SITE INSTRUCTION

SI A16

PROJECT : Forestside
PROJECT # : 1331.15
DATE : Jan.26, 2022

Title: Revisions to plans as itemized.

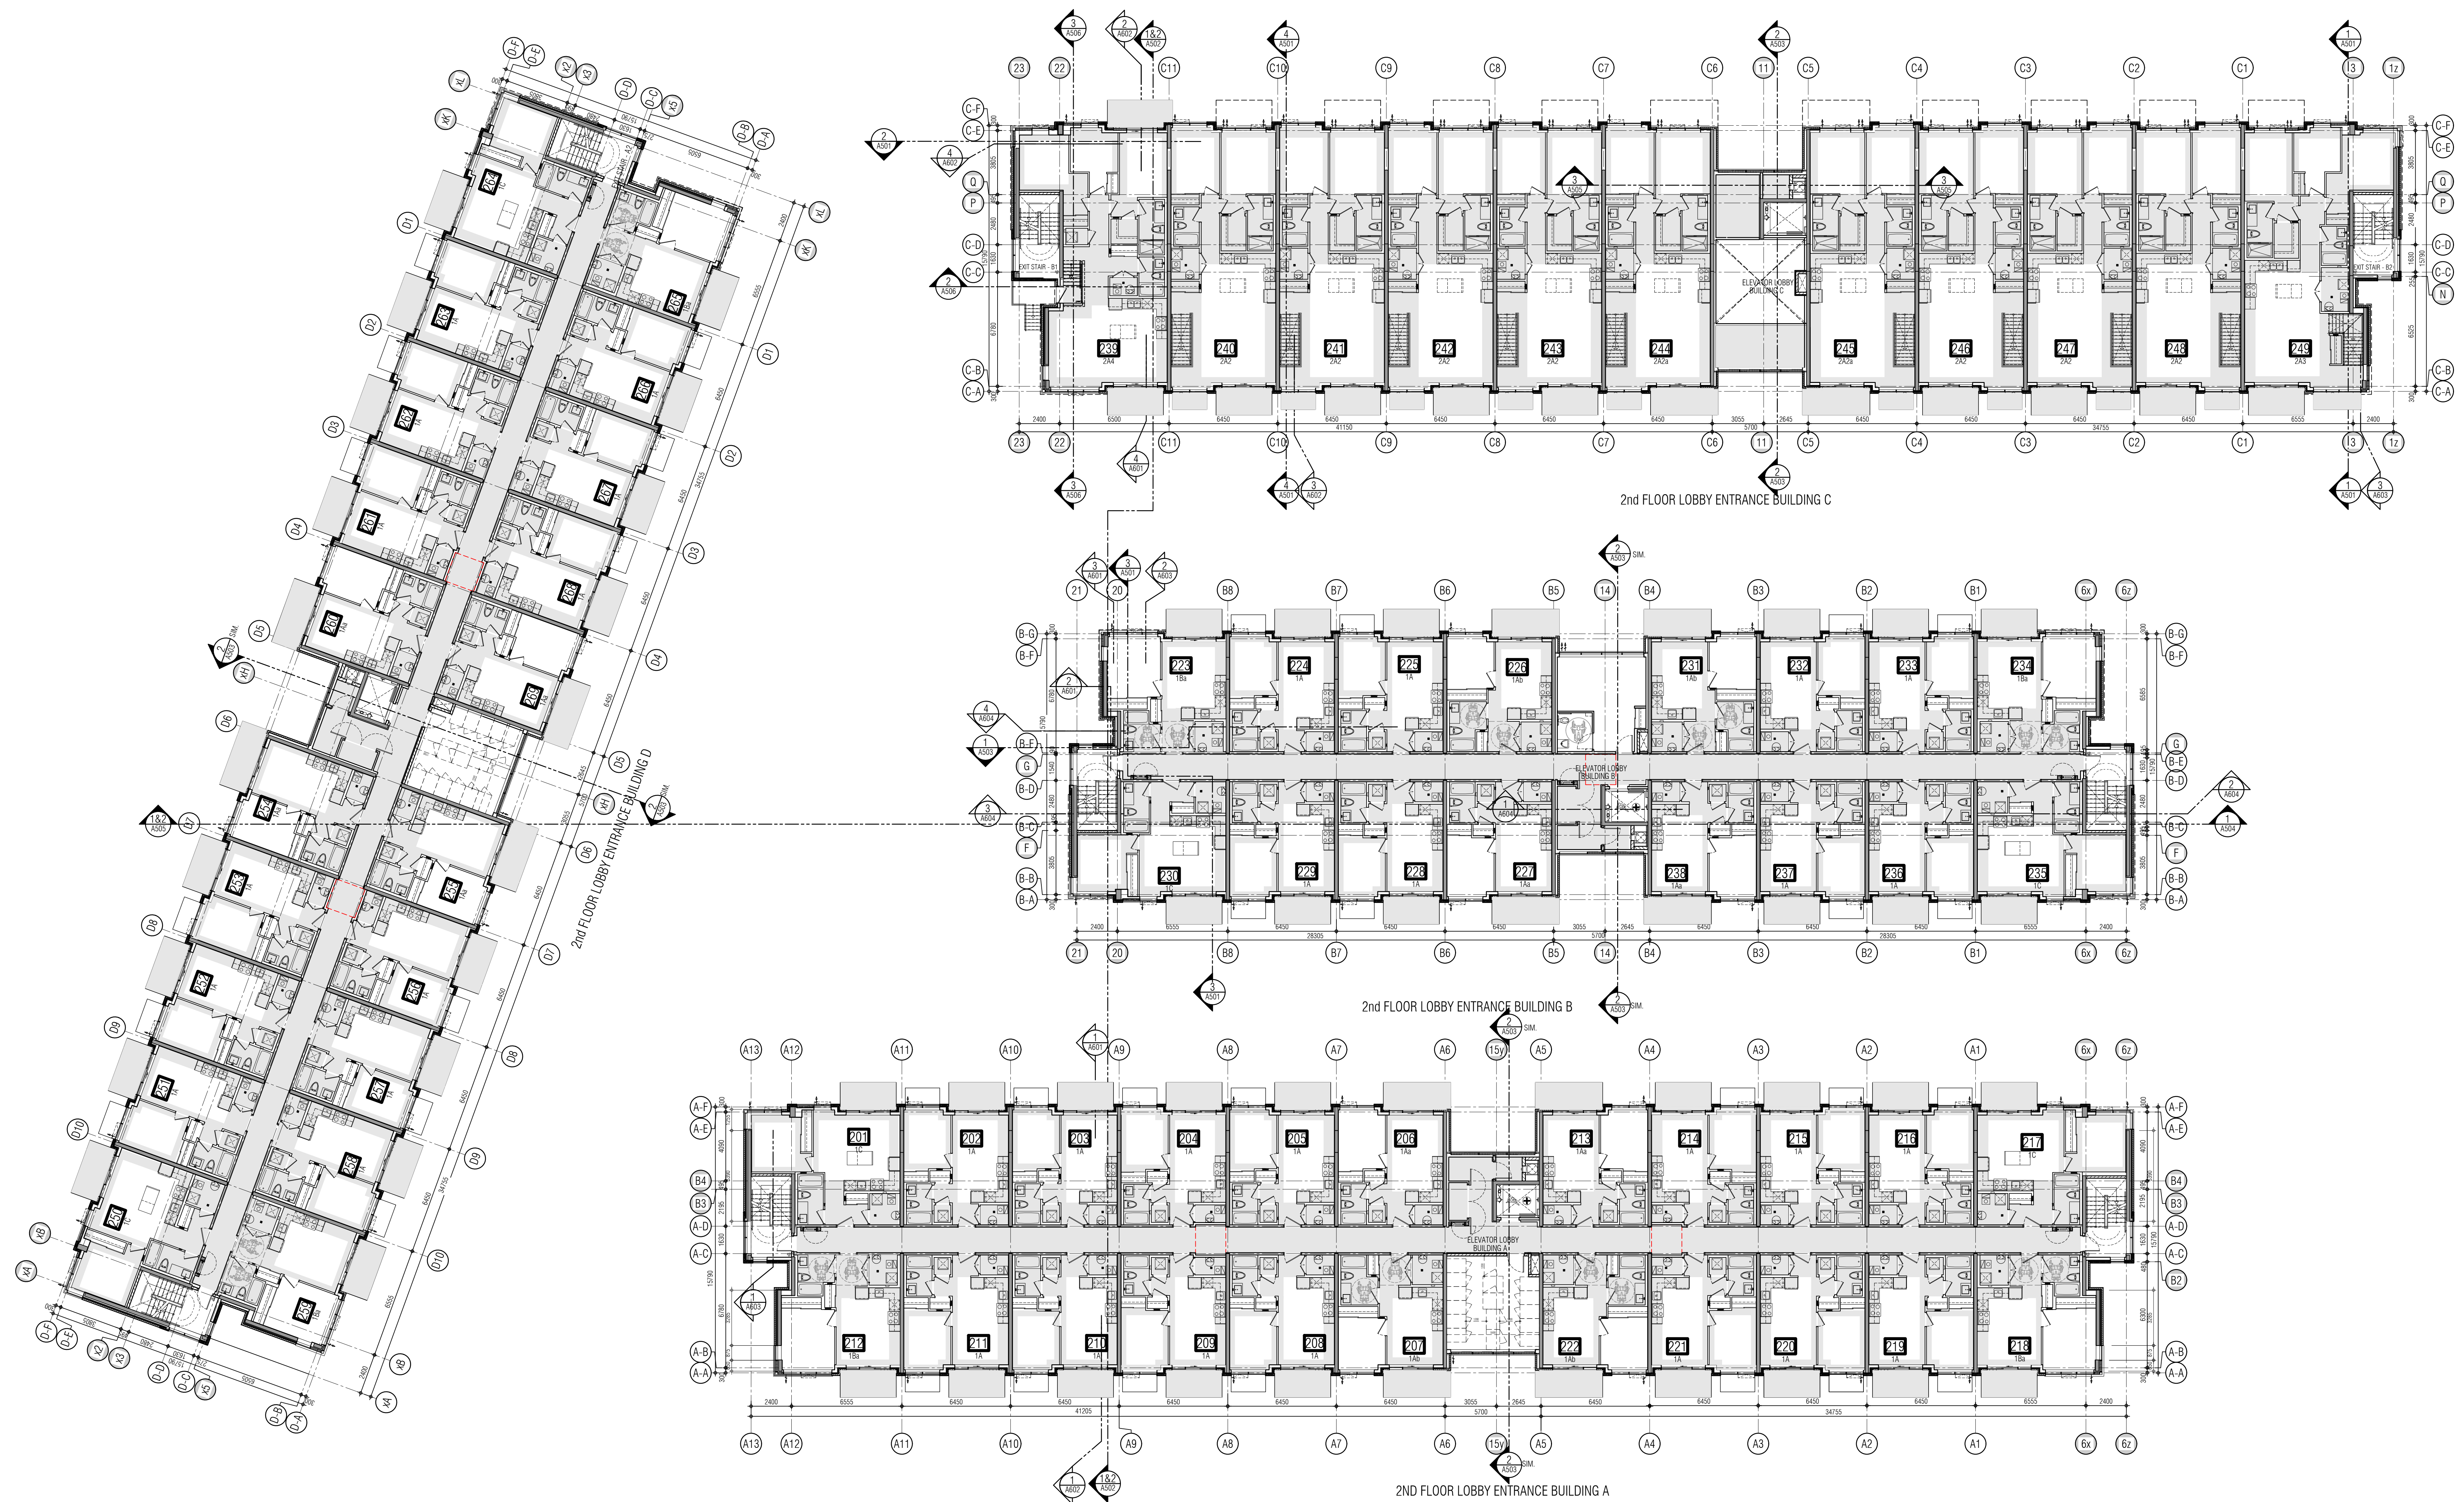
Reference:	Changes:
A103	Door Schedule	Add New T04 door to lockers and T05 door at JC/Whrm. At link building areas.
A302, A302a1, A302a2, A302b1, A302b2, A302d1, A302d2	2 nd Floor Plan Bldg. A, B, & D	Add New T04 door to lockers and T05 door at JC/Whrm. At link building areas.
A303, A303a1, A303a2, A303b1, A303b2, A303c1, A303c2, A303d1, A303d2	3rd Floor Plan Bldg. A, B, C & D	Add New T04 door to lockers and T05 door at JC/Whrm. At link building areas.
